เอกสารขอคำอธิบายเพิ่มเติม

โครงการ : ANDAZ RESORT PATTAYA

ถึง : บริษัท	บริษัท พี ไอ เอ อินทีเรีย จำกัด (PIA)	เลขที่ :	RFC.1909.211127.PIA.ECH.1(MEP-002)
เรียน :	คุณวรพงษ์ เทพสมรส	วันที่ :	27 พฤศจิกายน 2564
สำเนา :	คุณบุญฤทธิ บุญโพธิ์รักษา / MITR	จำนวนแผ่น (รวมแผ่นนี้) :	7 แผ่น

เรื่อง : ขอให้พิจารณาตำแหน่งความสูงการติดตั้งของ Outlet & TV เนื่องจากมีการเพิ่ม TV, Gym Room อาคาร B

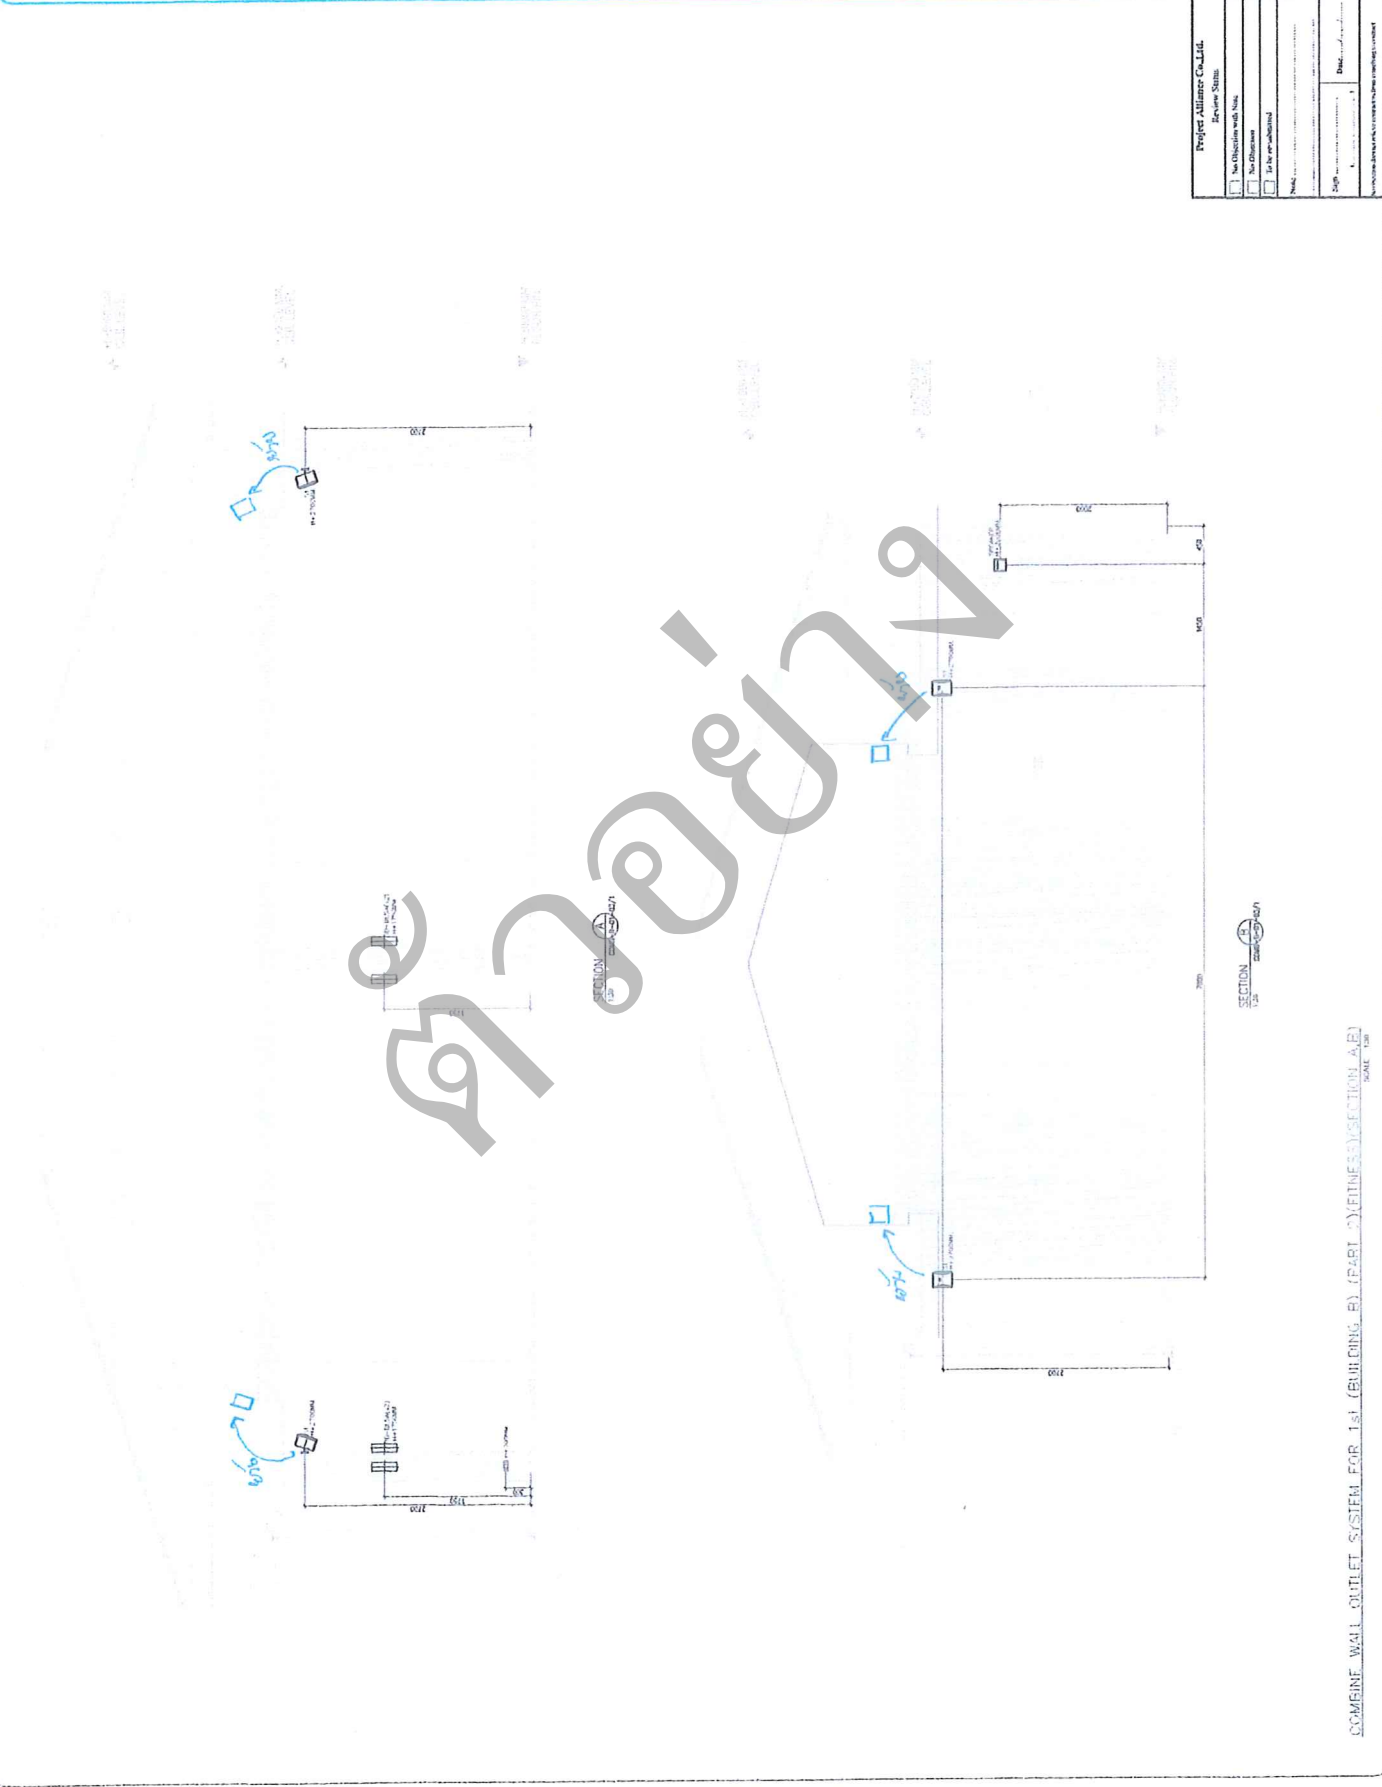
ที่	คำถาม	คำตอบ
1	ขอสอบถามเกี่ยวกับตำแหน่งความสูงการติดตั้งของ Outlet & TV เนื่องจากมีการเพิ่ม TV ห้อง Gym อาคาร B เพื่อจะได้ให้ทางทีมงานจัดเตรียมต่อไป	- 2.16 TV สูงจากพื้น 1200 มม - 2.17 ตำแหน่ง TV 1 จุดในชั้น 2 และ 3 สูงจากพื้น 1200 มม - 2.18 ตำแหน่ง TV 1 จุดในชั้น 2 และ 3 สูงจากพื้น 1200 มม 28.10.21

COMBINE WALL OUTLET SYSTEM FOR 1st (BUILDING B) (PART 2)(FITNESS)
SCALE 1:50

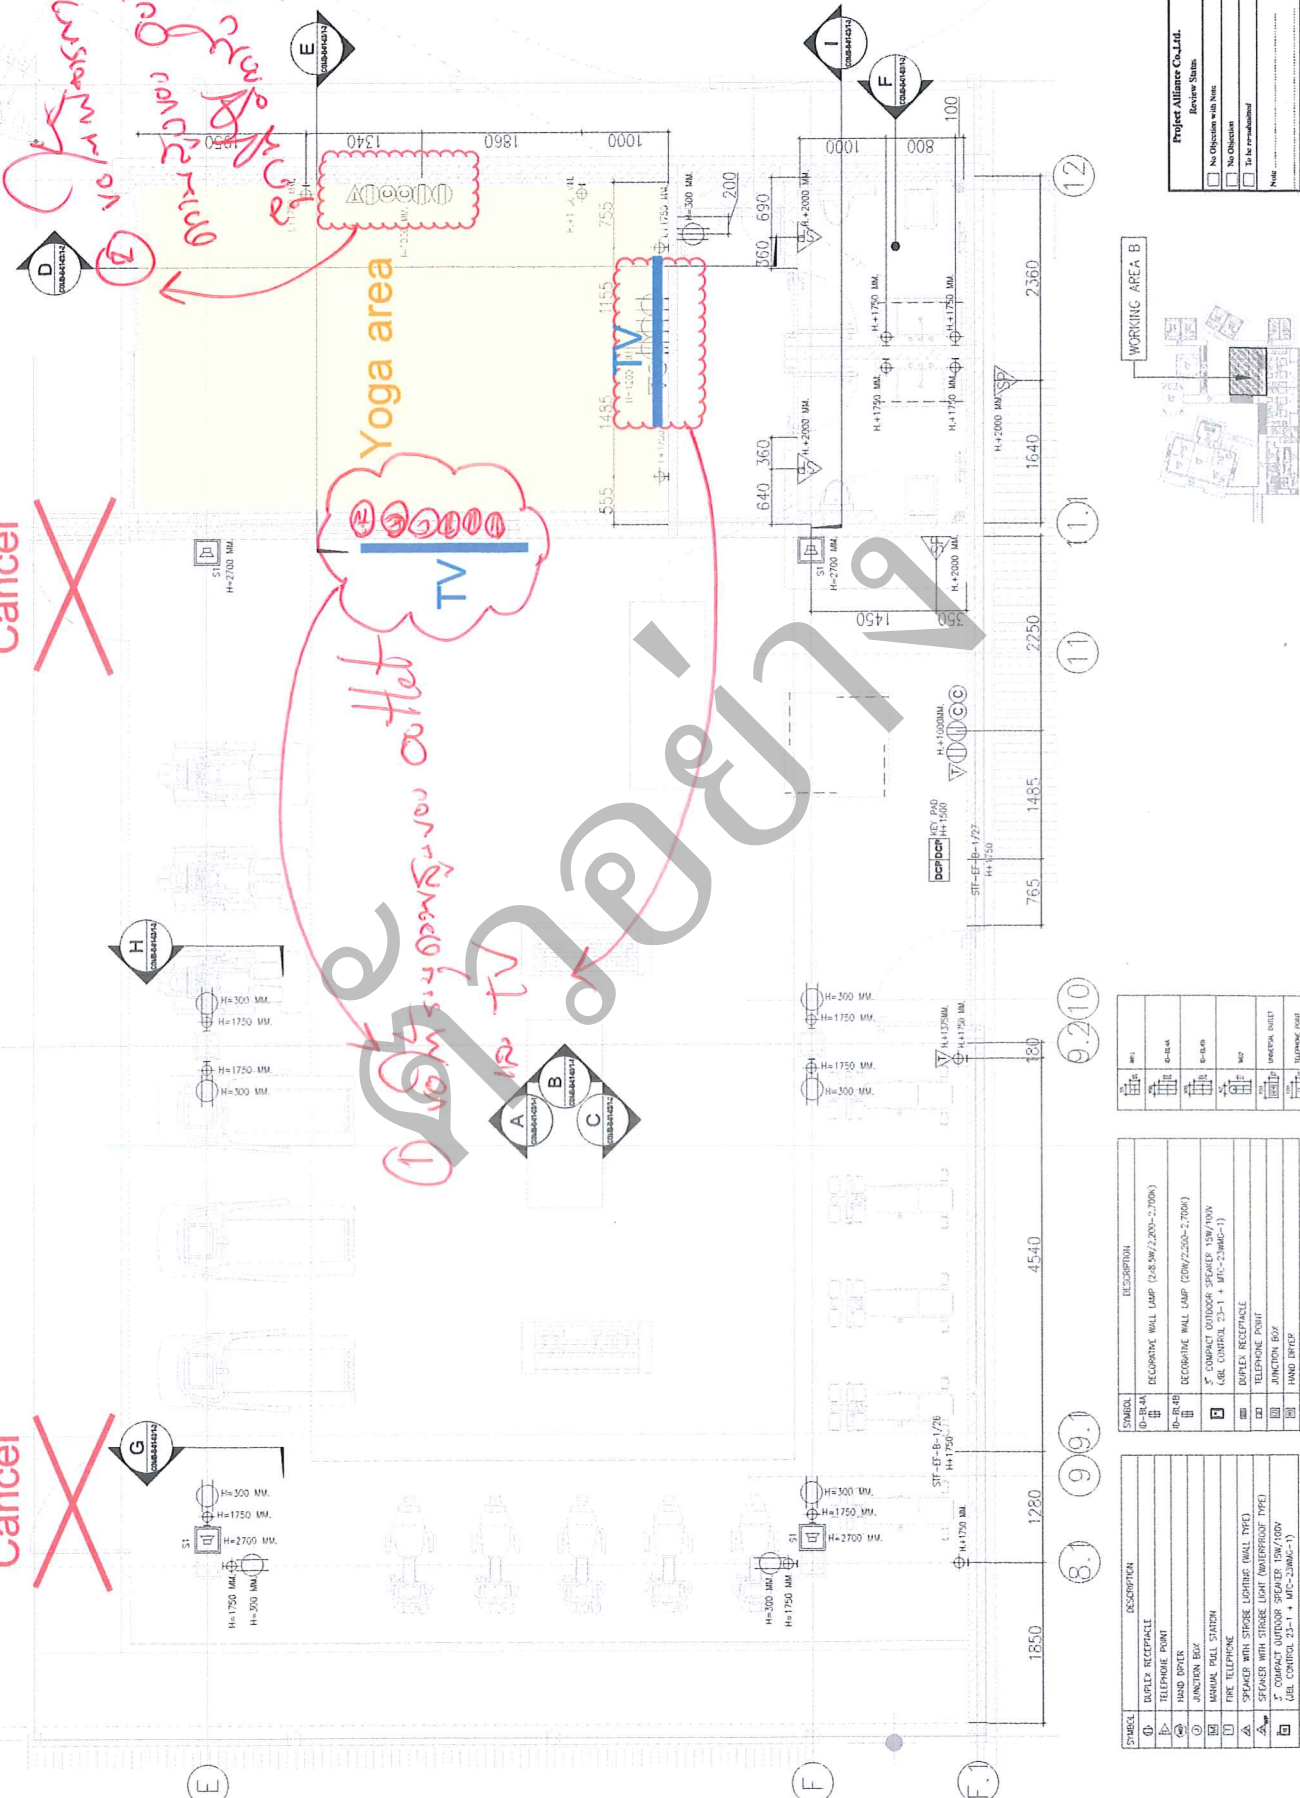
- โครงการฯ สรุปจะติดตั้ง TV ขนาด 65" ในห้อง Gym จำนวน 2 ตัว (1 ตัวอยู่ในห้องเล็กโยคะ) ตามตำแหน่งในภาพประกอบไฟล์แนบ
รบกวนช่วยประสานผู้ออกแบบและผม. เตรียมระบบและ Outlet สำหรับ TV ในระดับความสูงที่เหมาะสมครับ
- ภายในห้องเล็ก จะใช้งานเป็นห้องโยคะ ขอให้พิจารณาปรับลดระดับความสูงตำแหน่ง Outlet บนผนัง (+1000, +1200) ให้อยู่ระดับ
ล่าง (+300) เพื่อให้มุมมองภายในห้องโยคะดูโล่ง จะดีไหมครับ ? หรือยกเลิก Outlet ที่ไม่จำเป็นออกครับ?

Cancel

Cancel

- Handwritten in Thai: "ขอเพิ่มทีวี" (Add TV)
- Handwritten in English: "Add TV", "Yoga area", "TV", "outlet", "cancel"
